ADDENDUM

ADDENDUM NO.: 03
PROJECT NAME: WPA Street Reconstruction (E 109th St., S Hoyne Ave., S Harding Ave., E 102nd St.)
PROJECT NO.: 22312, 22313, 22314, and 22329
CONTRACT NO.: C1616
DATE OF ISSUE: December 2, 2024

NOTICE OF CHANGES, MODIFICATIONS, OR CLARIFICATIONS TO CONTRACT DOCUMENTS

Not To Scale

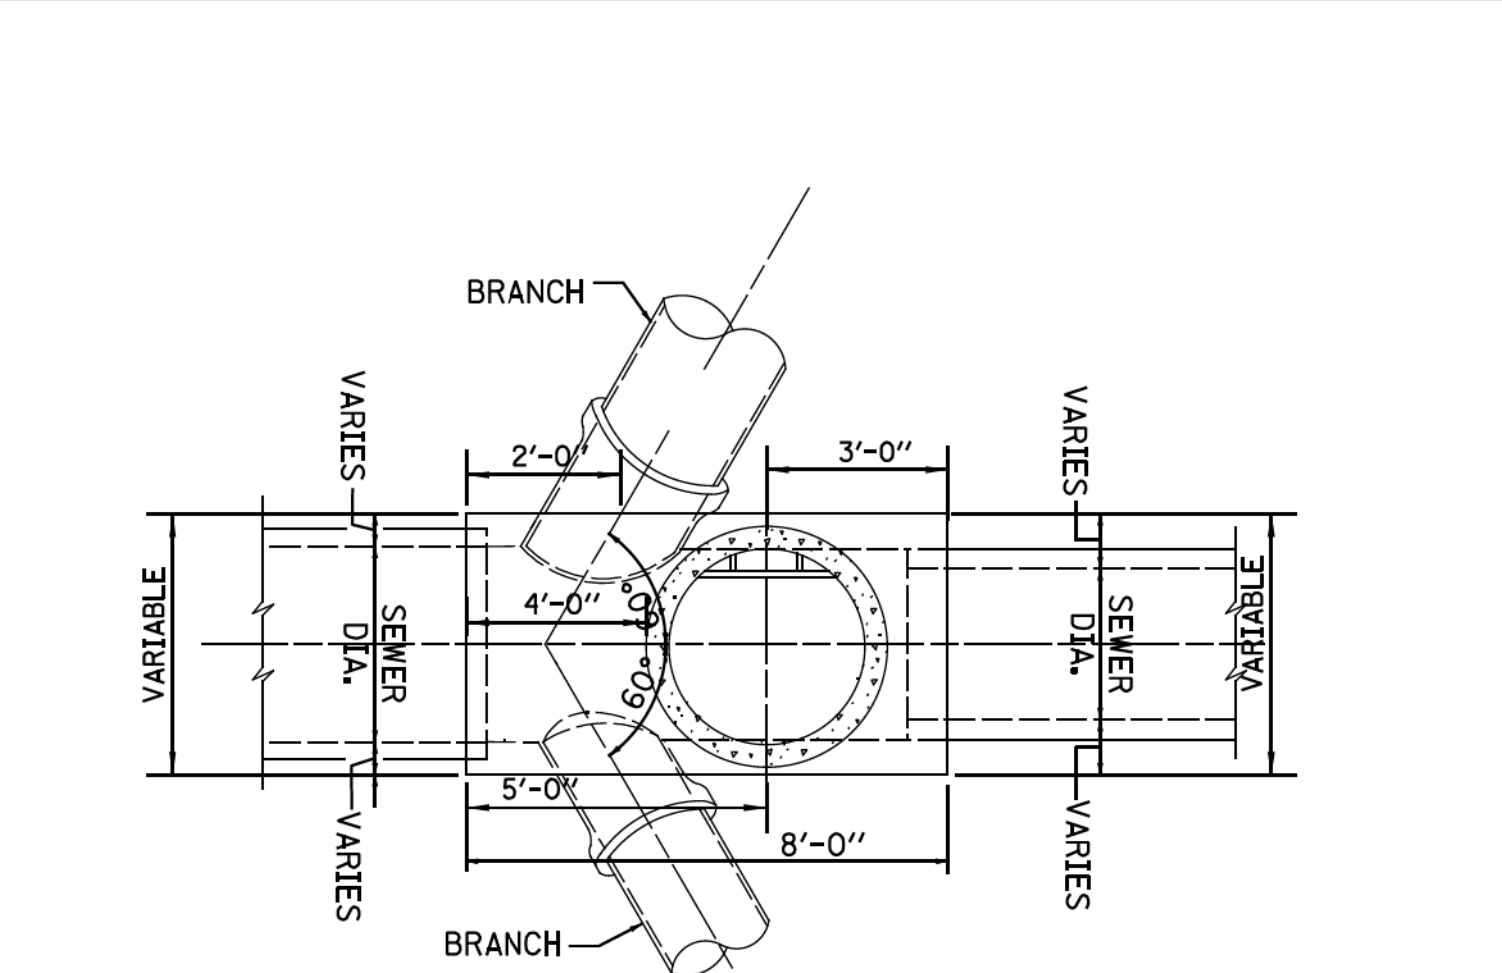
Change 3 ADD SHEET 31A CDWM Sewer Detail for E. 102nd

F.A. RTE.	SECTION	COUNTY	TOTAL SHEETS	SHEET NO.
		COOK	31	31B
CONTRACT NO. C1616				
ILLINOIS FED. AID PROJECT

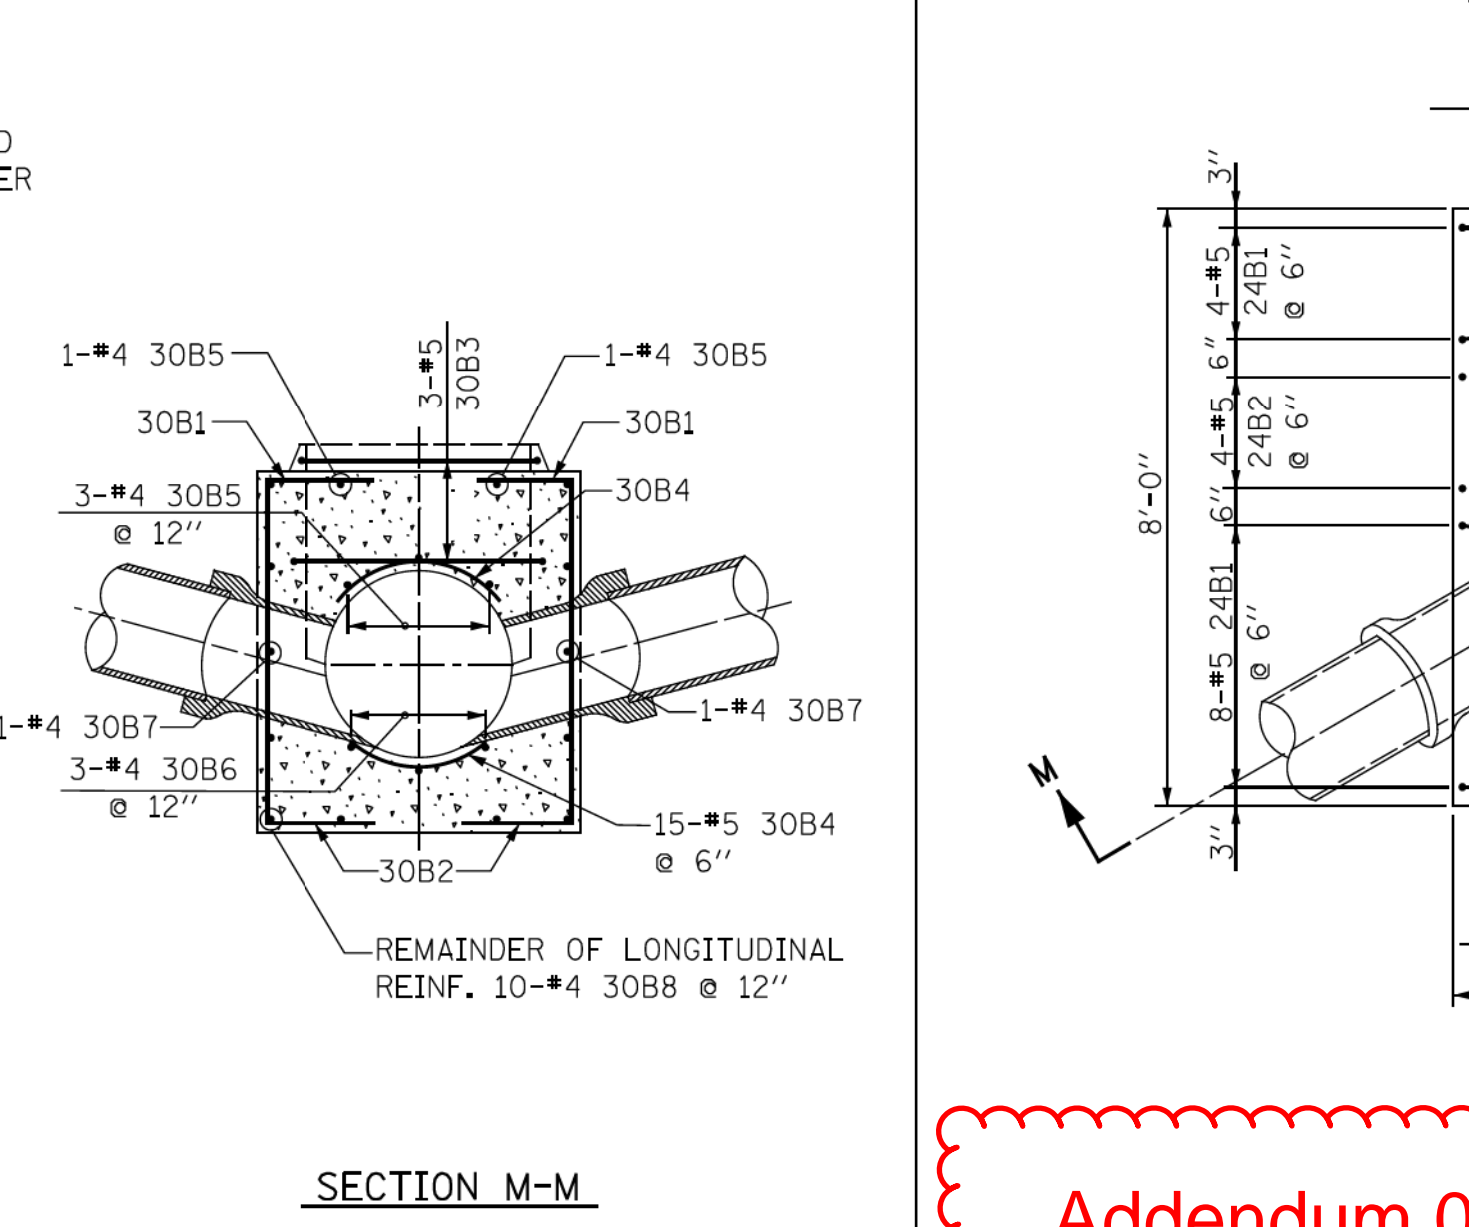
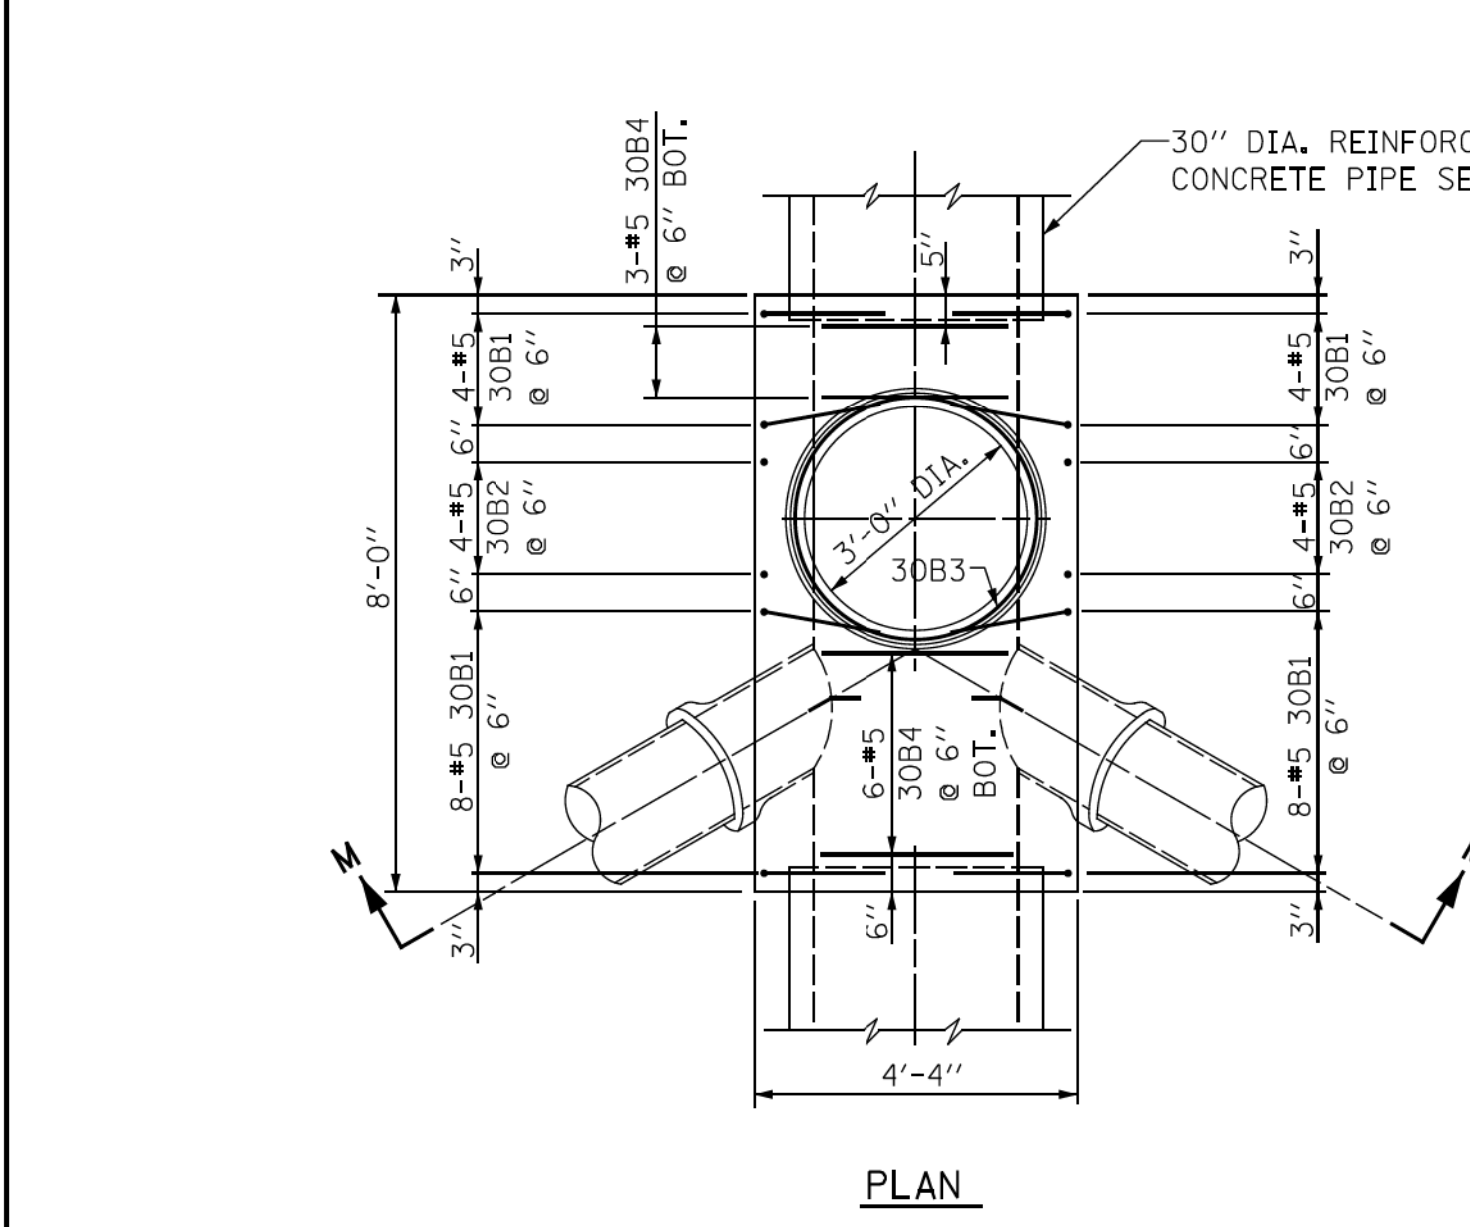
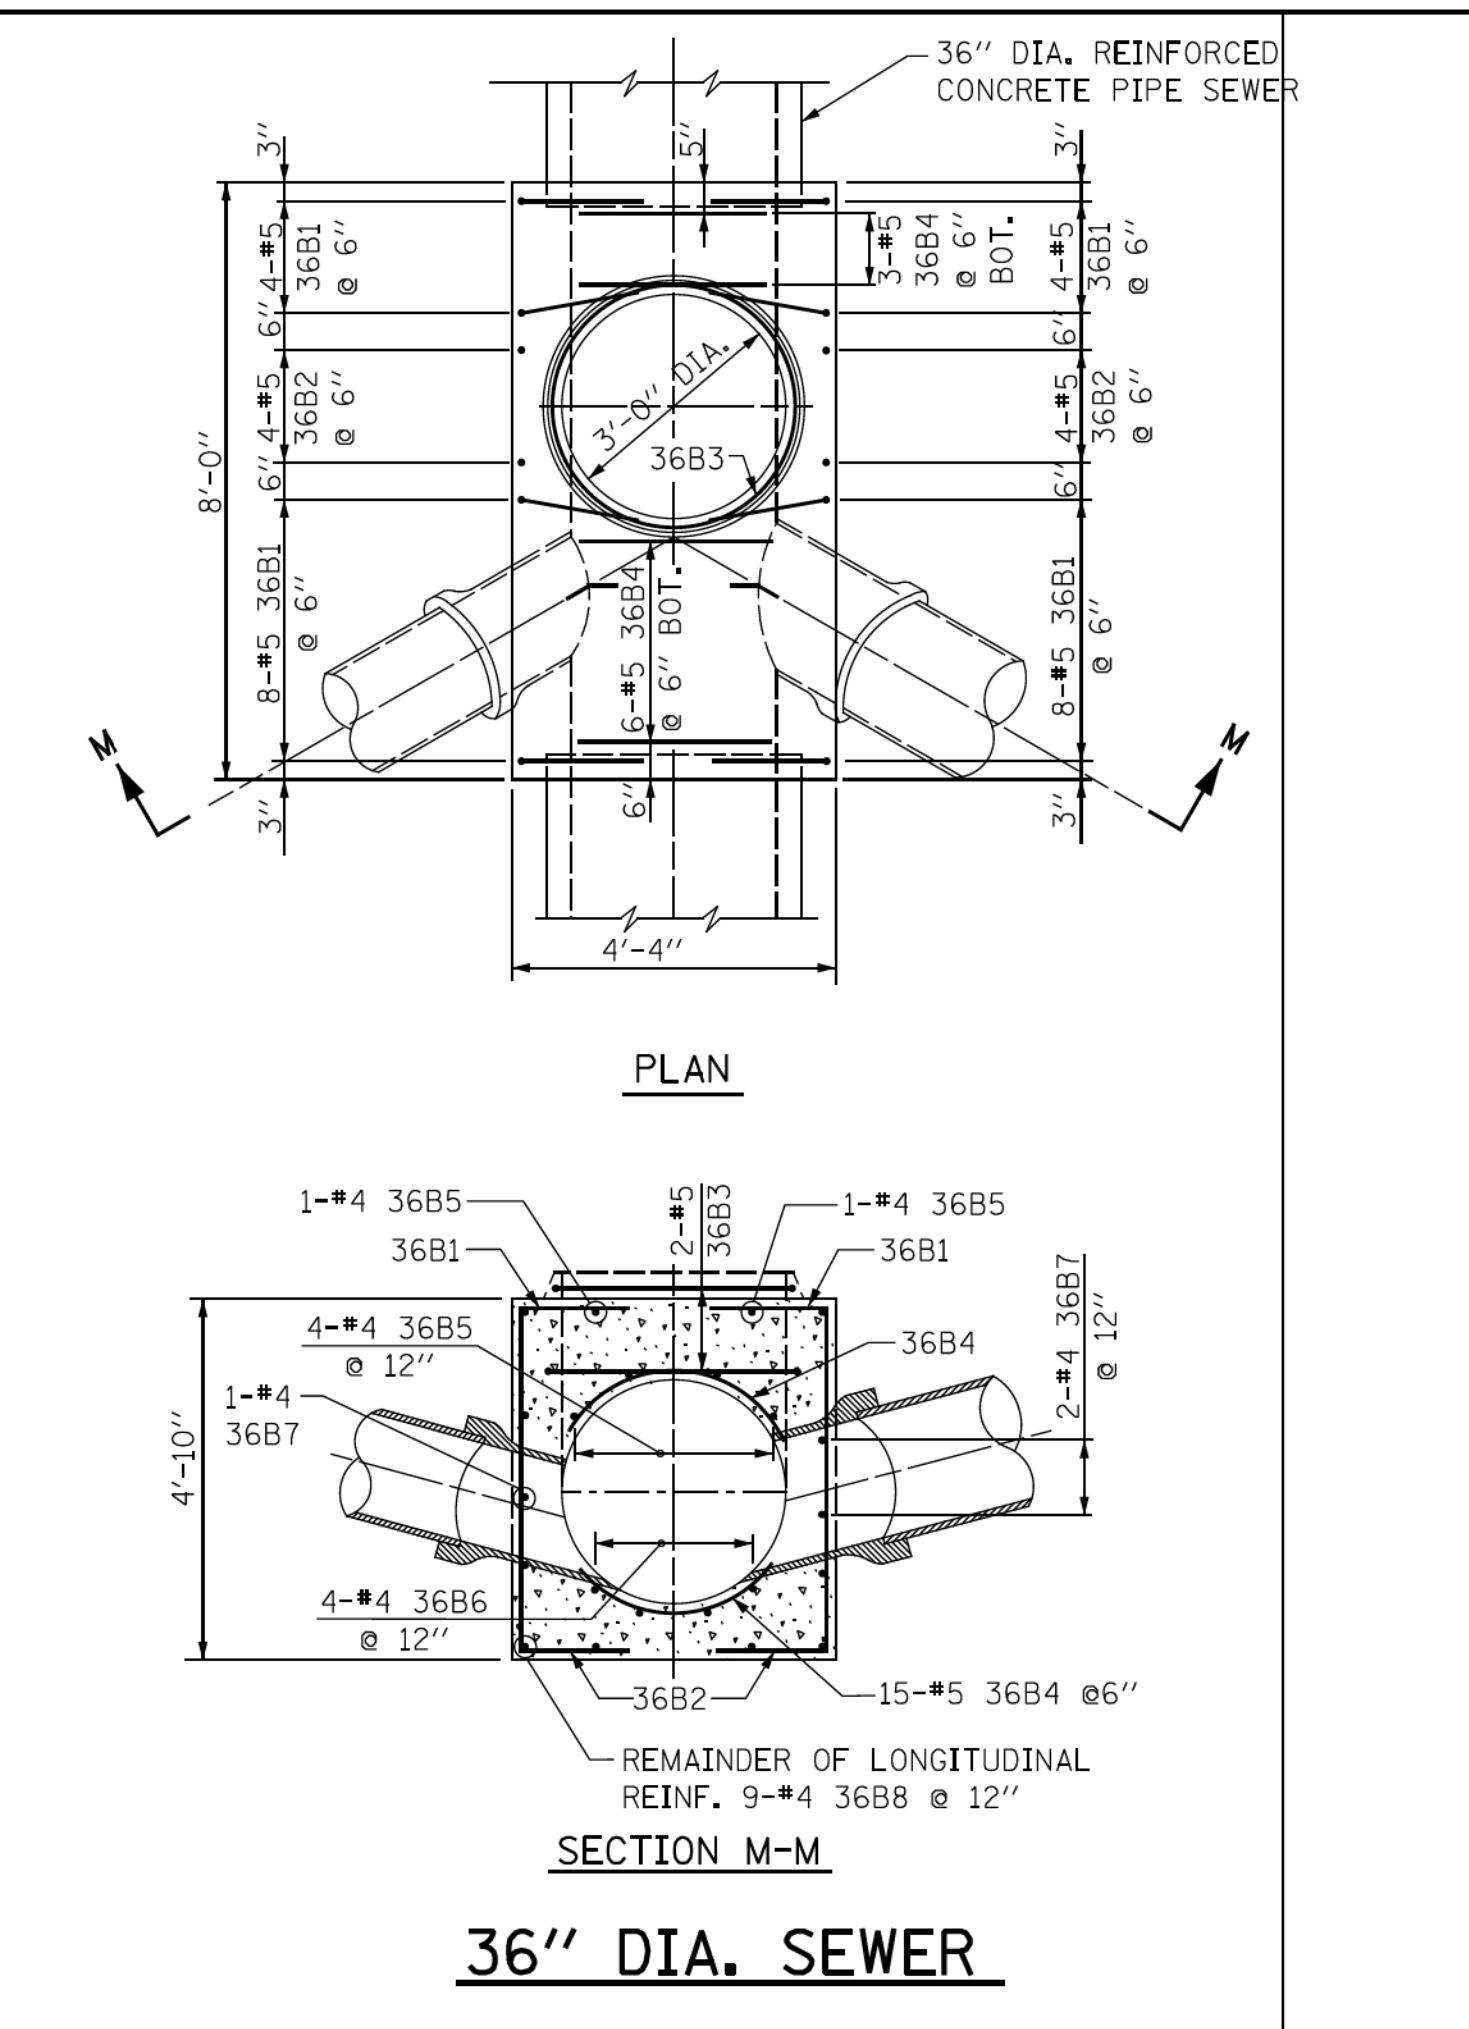
Change 4 ADD SHEET 31B CDWM Sewer Detail for E. 102nd
